RE: Draft San Jose Citywide Design Standards and Guidelines

FROM: Pedram Farashbandi, AIA
TO: Leila Hakimizadeh, City of San Jose
200 East Santa Clara Street, San Jose, CA 95113
RE: Questions and Comments on Proposed Citywide Design Standards and Guidelines

Fig. 4.15 Design multi-use *private open spaces* to be used by building occupants.

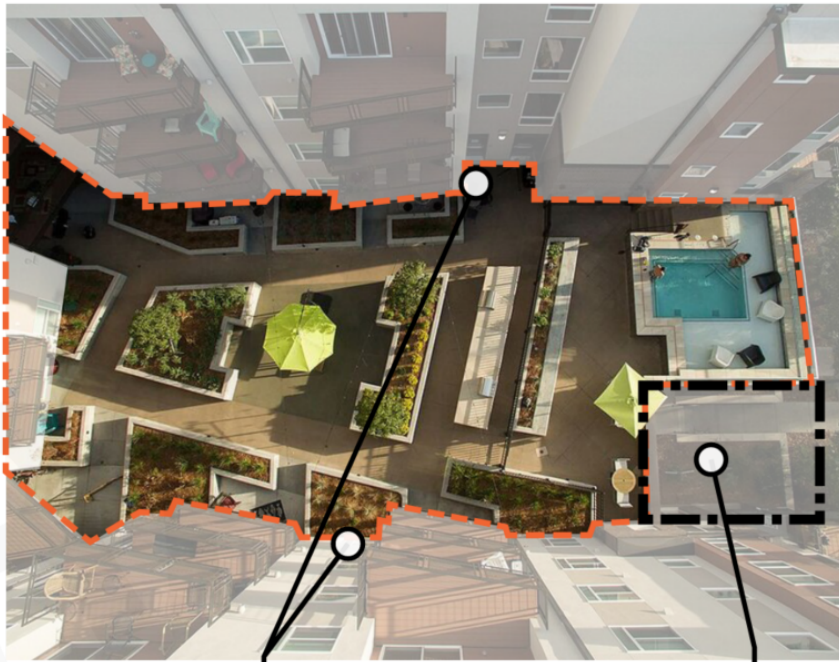
Q1: Please clarify figure 4.15 and the method for calculating the extents of a communal open space. In your diagram, some areas which are less than 20 ft are highlighted as part of the communal open space. And, an area which is open on the level below is not counted.

this is less than 20ft, but is counted

why isn't this counted

Fig. 2.18 Maintain the minimum width for paseos between a building and adjoining property line.

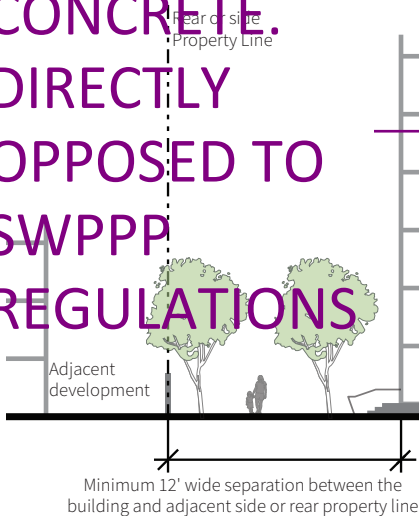
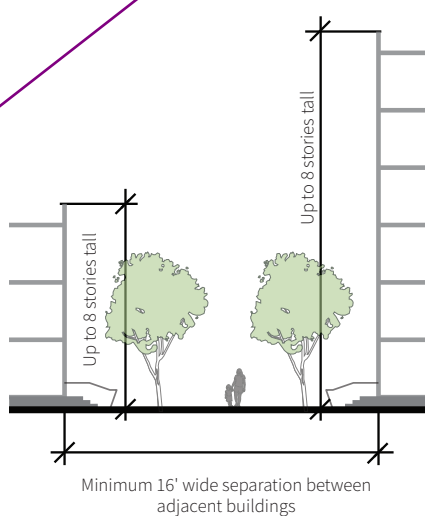
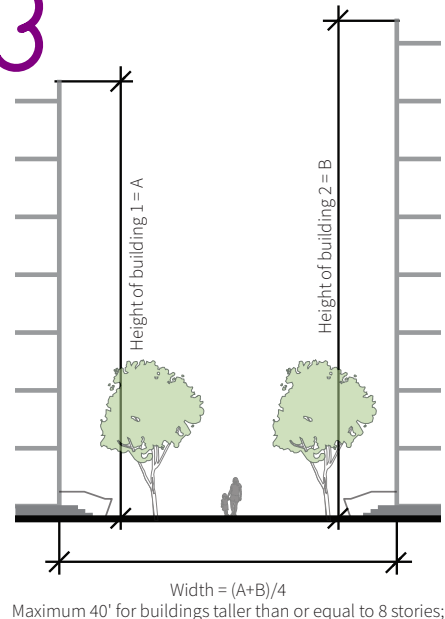
EXCESSIVE
CONCRETE.
DIRECTLY
OPPOSED TO
SWPPP
REGULATIONS

Fig. 2.37 Enhance public spaces, improve site organization and improve environmental quality by using *LID* for landscaping.

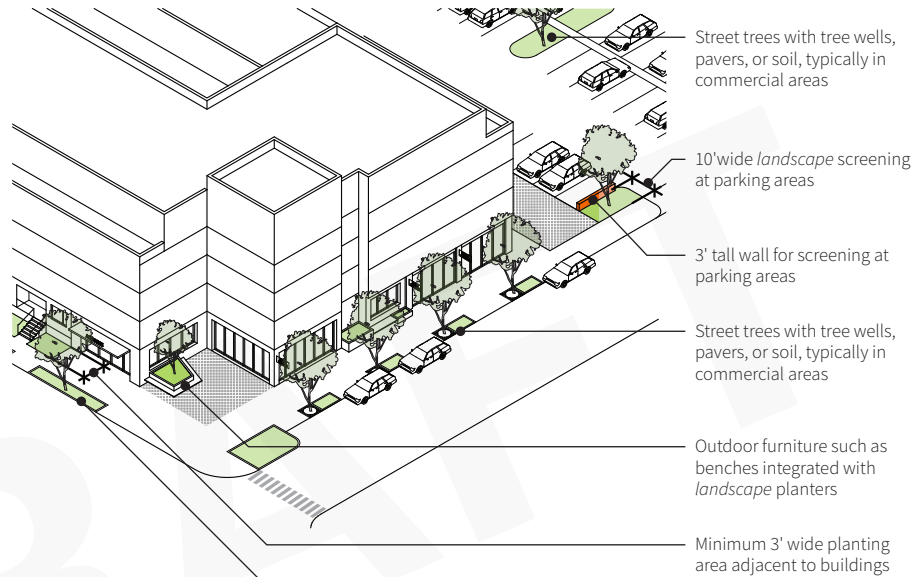
IF THE BUILDING HAS TO HAVE 5' MIN SETBACKS HOW CAN YOU ADD THESE TREE WELLS

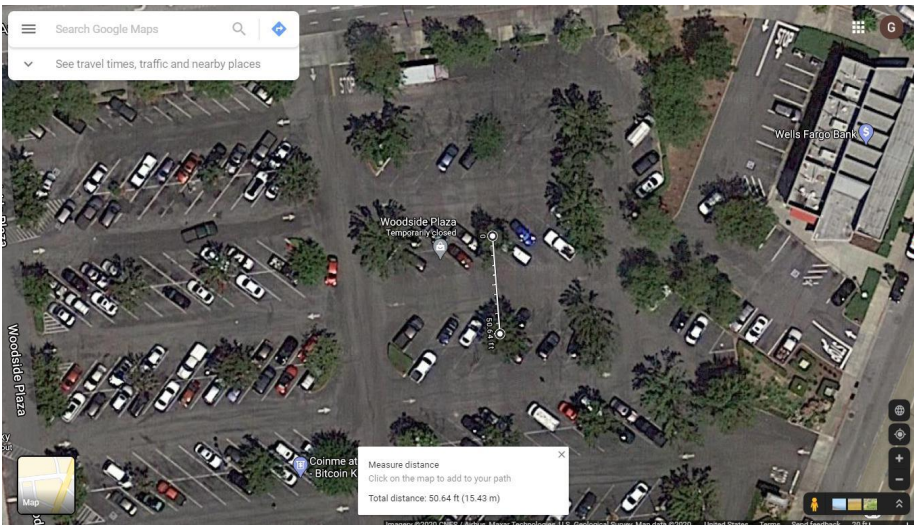
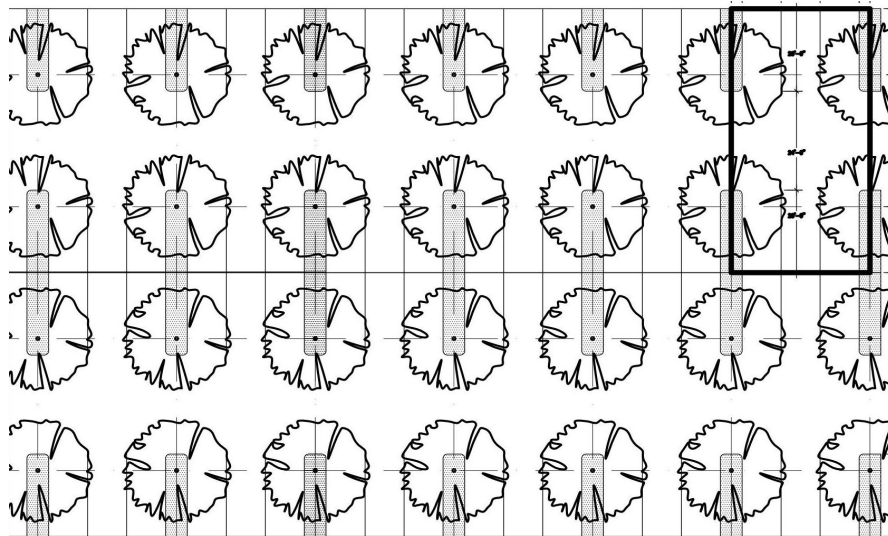
Typical urban heat island- Photo 1 shows a typical urban parking lot with **10 parking spaces between trees**.

Urban heat island - Photo 2 shows a retail parking lot -Spacing is 50' apart with 50' wide aisles - with **50 year old** mature trees, mostly ornamental pear with mulberry trees (larger canopy) at ends of aisles. . There is not enough shade to cool the pavement.

In order to reduce the urban heat island effect, it is important to revise the guidelines to establish a minimum spacing of trees.that provides significant tree cover and shades hot parking lots and sidewalks. On the

increasing 90-100 degree hot days¹, asphalt parking lots get as high as 130-150 degrees Fahrenheit. This raises surrounding temperatures and is hot enough to burn the bare paws of dogs, including seeing-eye and assistance dogs. Medium rare steak is between 125-130 degrees.

Ideal tree spacing: Parking lot trees, in an urban context, are usually medium trees (Sec.2.4.6 S4), an ideal parking lot grid has trees at a grid of 32' x 32' feet apart which translates to a tree every three spaces with a planting well 5' wide. *See below*. This provides shade for the asphalt and keeps the ground cool. All tree wells should be used as a bioswales for green stormwater infrastructure (G5) to filter out the parking lot pollutants of oil, and toxic brake dust and tire dust.

2. PARKING LOT WITH 32' X 32' GRID OF TREES
BIOSWALES AT TREE ISLANDS . 5' X 40' FOR DRAINAGE
PERMEABLE CONCRETE WOULD ALLOW ADDITIONAL DRAINAGE

Insert wording: "In order to add to the urban tree canopy, trees in parking lots shall be spaced every 3 spaces, in a tree well which is 5' wide minimum. Tree wells shall be used as bioswales wherever possible. Trees shall be selected from the city's tree list, preferably native species, for habitat value and drought tolerance and be irrigated for the first 5 years"
